DETAILED OFFICER REPORT APPLICATION FOR DEVELOPMENT APPROVAL

SUMMARY SHEET				
Applicant:	Stockland (Development) Pty Ltd			
Owner:	Stockland (Development) Pty Ltd			
Consultant:	RPS Australia East Pty Ltd			
Proposal:	 Preliminary Approval for Material Change of Use of Premises (including a Variation Request to vary the effect of the Sunshine Coast Planning Scheme 2014) for Residential, Business, Community, and Sport & Recreation uses Development Permit to Reconfigure a Lot (4 Lots into 182 Lots, new roads, parks and balance lot, over 2 Stages) 			
Properly Made Date:	19 December 2018			
Information Request Date:	31 January 2019			
Information Response Received Date:	17 May 2019			
Further Advice Date:	22 August 2019			
Further Advice Response Received Date	2 October 2019 (All except Hydrology information			
	14 October 2019 (Hydrology information)			
Decision Due Date: Number of Properly Made Submissions:	1 July 2020 417 submissions were received, with 132 in support and 285 opposed to the development. Of these submissions, 388 submissions were properly made

Figure 9 - Proposed Open Space Plan

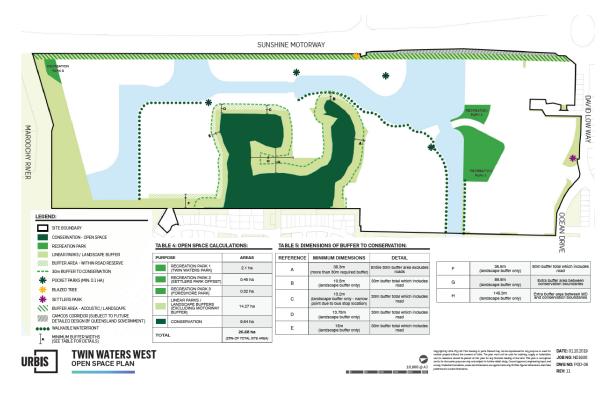
- Minimum 100 metre buffer (with an average of 150 metres) to the highest astronomical tide in lieu of 150 metres
- Minimum 20 metre buffer to the Sunshine Motorway in lieu of 40 metres

As noted above, the development does not provide the minimum 30 metre rehabilitated buffer to the ecological important area with the proposed:

Figure 11 - 150 metre offset to Highest Astronomical Tide

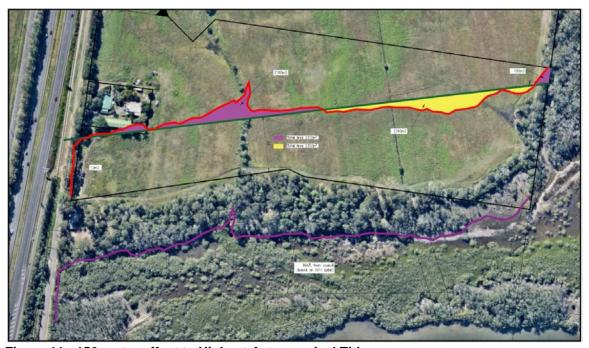
Given the irregularity of the highest astronomical tide line, the applicant has proposed to average the buffer to establish a more regular delineation of the offset line for development as shown below.

The areas below the highest astronomical tide areas are shown within an open space reserve and where removed for the lake interchange/fish passage will be "offset" as required by the State Government (see Concurrence agency response).

Figure 13 - Cross Section of CAMCOS Corridor

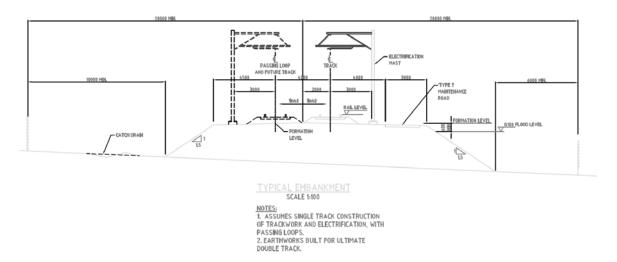
The Department of Transport and Main Roads are yet to identify a specific design for the CAMCOS corridor future infrastructure provisions and therefore the specific width of the corridor is still unknown for this section of CAMCOS. This corridor is unlikely to be required in the short to medium term, but protected to preserve the corridor to occur unencumbered if and when the CAMCOS is required to be delivered.

If the proposed 20 metres buffer is accepted, there is a risk that the State Government will require some or all of the land from within this vegetated buffer area to accommodate the CAMCOS public transport link in the future. This would address the *Regional infrastructure overlay code* as there is a 40 metre wide area capable of being used for CAMCOS. However, in their role as a concurrence agency, the State Government have not nominated any width or additional land requirements, presumably because the State may potentially remove all or part of the vegetation to accommodate

However, in the event that CAMCOS proceeds at some stage in the future, it is likely that parts of the vegetated buffer could be retained within the edge buffers (of 6 to 10 metres) or the battered slope (which would assist with stabilising this area). Further, the State Government would need to review the acoustic barrier effectiveness, as traffic noise sources may be closer or additional (e.g. light rail) to provide improved barrier attenuation if warranted.

Figure 14 - Proposed Open Space Plan

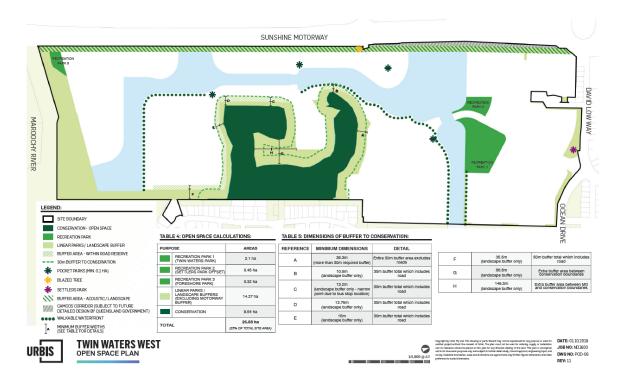
In relation to the above plan, it is recognised that Settlers Park is reduced in size as this is the nominated entry location in the local plan code. This is considered in the planning scheme in the below acceptable outcome

Consideration was given to either the park to increase in size in its current location, or the area being offset elsewhere on the site. Given a lack of parking and likely useability given its location on a roundabout or signalised intersection, the most acceptable option is to provide the offset land elsewhere on the site. The applicant's response to this matter was to offset the land in a new Park 2.

The mango trees and associated park furniture and monument should be retained, consistent with the local plan code. As noted in the Heritage and Character Areas section of this report, conditions can be applied in the event of approval to ensure protection Settlers Park mango trees, *Mangifera indica*. Further, conditions can be applied in the event of approval regarding the landscaping treatments for the remaining section of Settlers Park.

Figure 18 - Developed conditions – Ultimate catchment fill – regional flood impacts 1% annual exceedance period Climate Change event

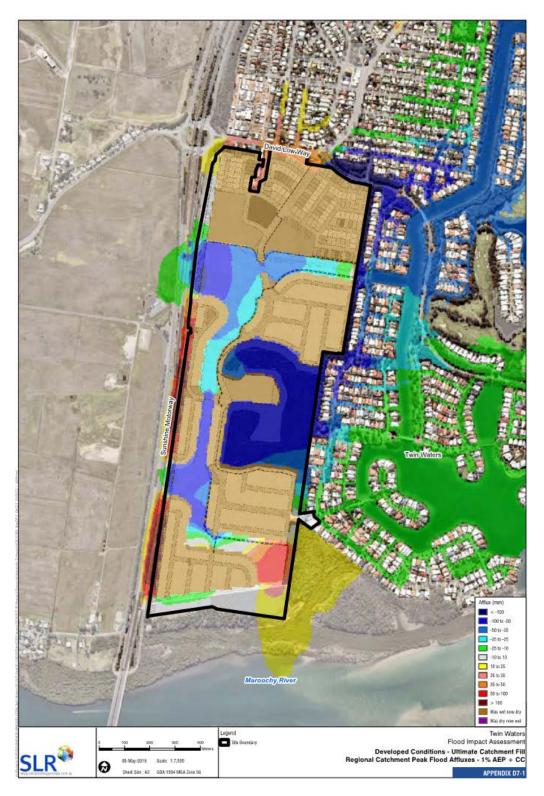
In general, the development results in more floodwater being directed into the Maroochy River than in the existing case and as a result of this, flood levels in the existing surrounding urban areas are slightly reduced.

Figure 31 - Plan showing overlap between Key Resource Area and Twin Waters West development

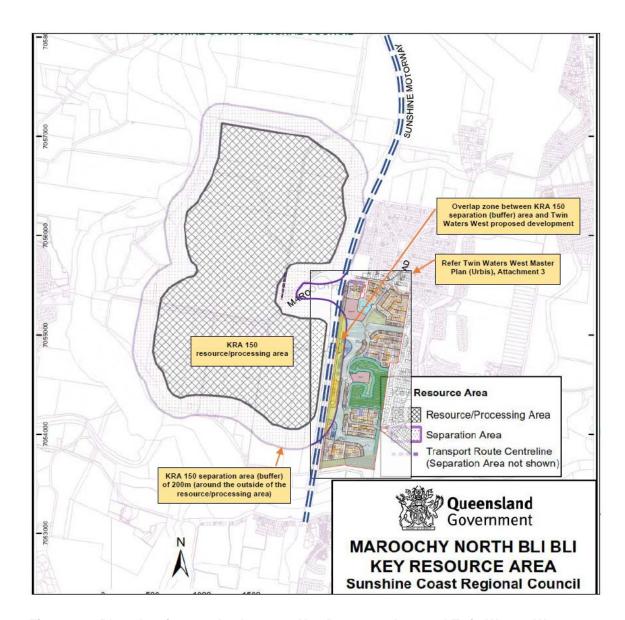
The Extractive resources overlay code requires that development does not result in an increase in the scale or density of residential uses within an extractive resource separation area. Further, reconfiguring a lot within an extractive resource separation area should not result in the creation of additional lots used or capable of being used for residential purposes.

Figure 35 - Plan showing properties adjoining the proposed Twin Waters West development

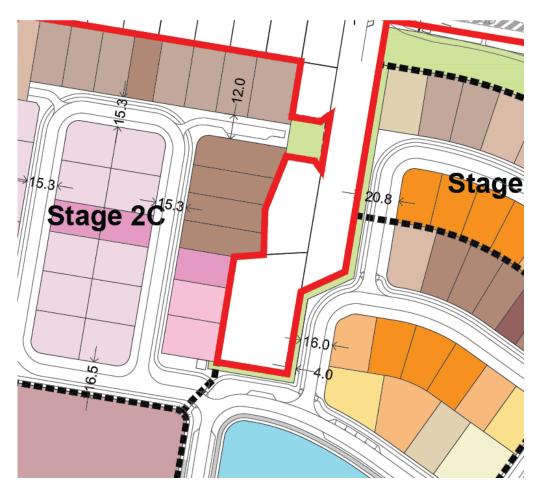
Submissions were received from owners along De Vere Road that raise concern about the interface between the residential allotments on De Vere Road and along the eastern edge of the development.

- interallotment drainage to ensure the existing properties are not impacted by stormwater runoff from Twin Waters West; and
- providing landscaping within the rear of both the proposed and existing allotments to preserve the amenity of the existing residents.
